# ***Foreign Missions Center at the Former Walter Reed Army Medical Center***

## ***Record of Decision***

**U.S. Department of State  
March 2019  
Washington, D.C.**

Figure 1: Summary of Recommended Improvements

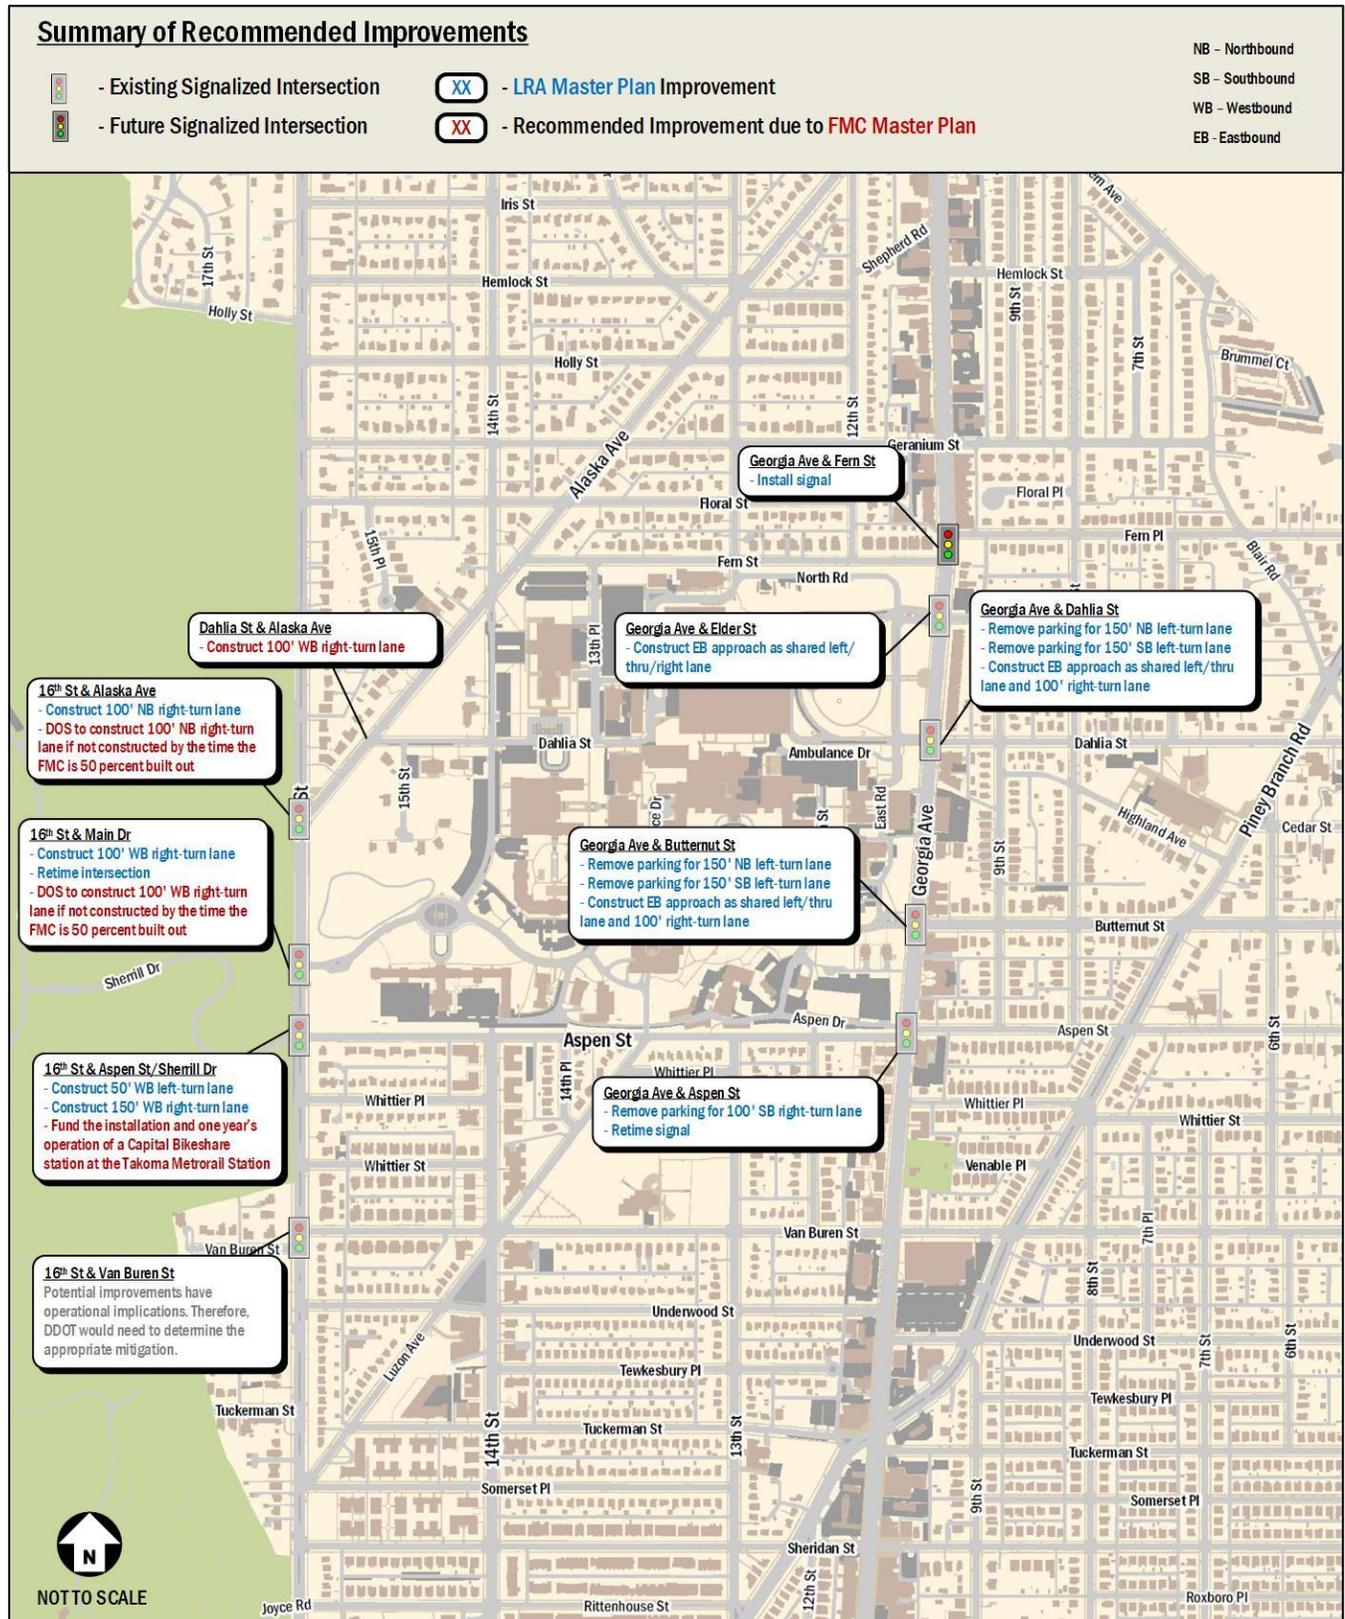
Response 2: As requested by DDOT, Gorove/Slade completed an additional review of the vehicular capacity analysis results of the FMC. Based on the revised version of the FMC Comprehensive Transportation Review (CTR) performed by Gorove/Slade in March of 2017, a subsequent Comment Response Memorandum submitted to DDOT in June of 2017, and comments raised at the July 12 DDOT meeting, DOS is committed to the following mitigation measures as summarized on **Figure 1 (in red)**:

- *16<sup>th</sup> Street & Van Buren Street*  
The FMC development triggers mitigations at additional intersections; however, the majority of these intersections will be upgraded and improved as a result of the LRA redevelopment (as shown in blue in Figure 1). The only intersection in which the FMC and LRA developments are not proposing mitigations is at the intersection of **16<sup>th</sup> Street and Van Buren Street**. It is important to note that this is an existing condition that will continue with future redevelopment of WRAMC.

Fig. 3: Walter Reed Army Medical Center Campus Map (c. 1955)  
FMC property is highlighted in red. Drop-off, cul-de-sac, at entrance of Building 54 is circled in blue

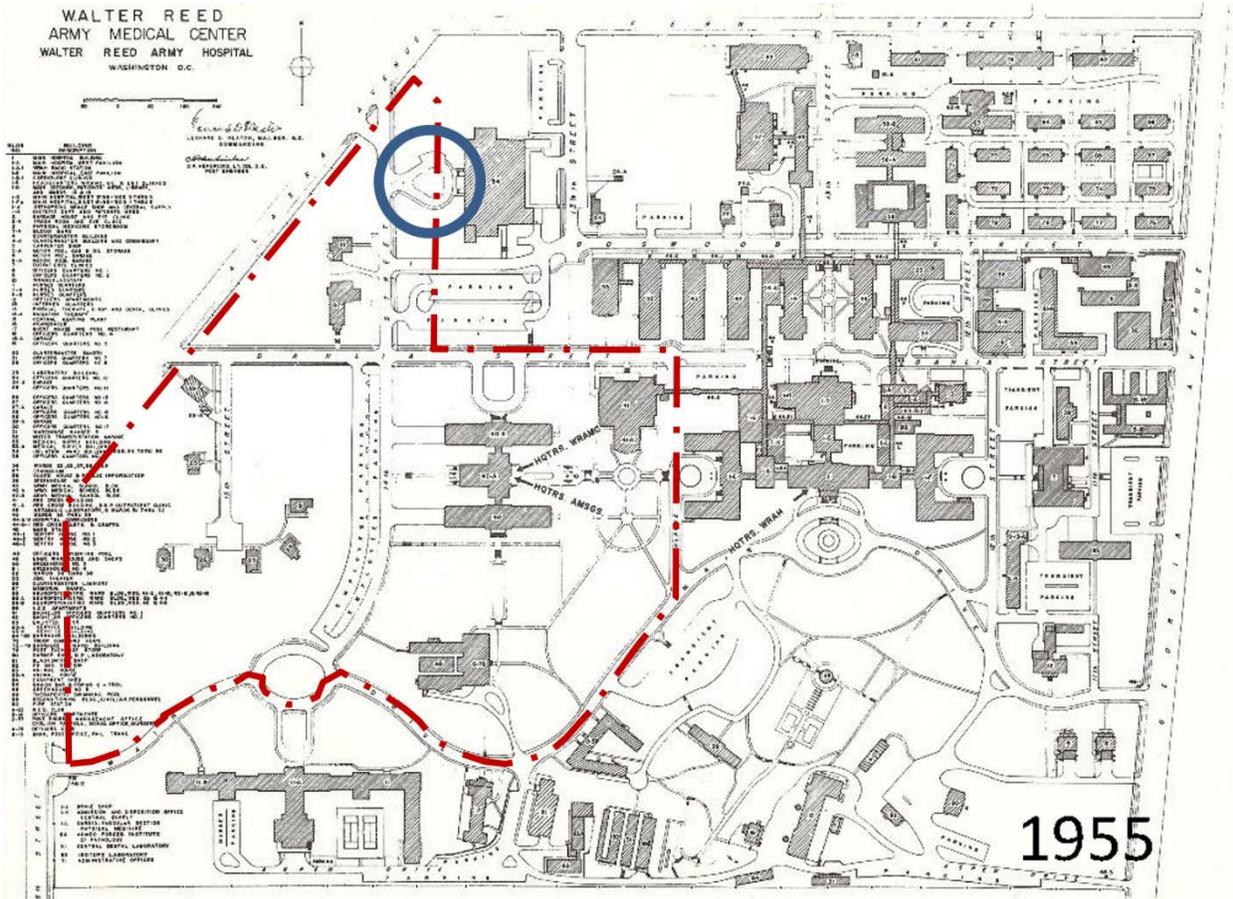
The resource implications of the cul-de-sac vs. through street option are presented in SDEIS Exhibit 2.4. Section 2.3.2 has been revised to state that the cul-de-sac option has been selected as a component of the Preferred Alternative in the FEIS because it:

The cul-de-sac option avoids impact to the contributing historic resource wrought iron perimeter fence and is consistent with the development history of WRAMC during the period of historic significance of interrupting continuity of urban street grid by using the same location as the historic turnaround in front of West Entrance to Building 54. The new owner of Building 54, Children’s National Medical Center, endorses this design.
